Urgent Product Correction Notice

Our Ref: 5173-1 FSCA

FSCA 5173-1 - MYLA V4.8.0/4.8.1 and MYLA V4.7.0/4.7.1 - Changing AST result from Sensitive to Resistant when sending data to Laboratory Information System

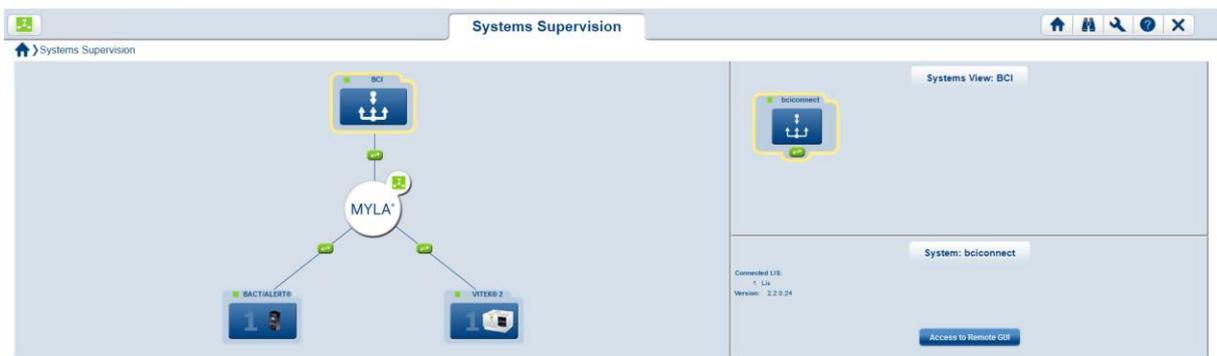
Due to the anomaly in the script's configuration, when the ExpertCategory value was missing in the result, the drug was disregarded in the counting of the index/number.

Then, during the 2nd step of the script, when the change in value was applied on the drug using its number/index, the count was exhaustive.

This resulted in a shift of index between a drug with "(-)" value and a drug where the "R" value was applied, which caused a value of "R" to be applied to the drug just before in the list, hence changing the result for this drug in the LIS from "S" to "R".

- Update your MYLA version as soon as possible with the incoming new software version of MYLA 4.8.2 that is already available on the market since 22-APR-2021 by contacting your bioMérieux local contact.

- Stop using the rules that allows to change the value in field a4 (Final Category) when using MYLA with BCI Connect (MYLA V4.7.0, 4.7.1 and patched version, MYLA V4.8.0, 4.8.1).
 - Schedule an appointment with a bioMérieux Field Specialist Engineer in order to proceed with the script changing.
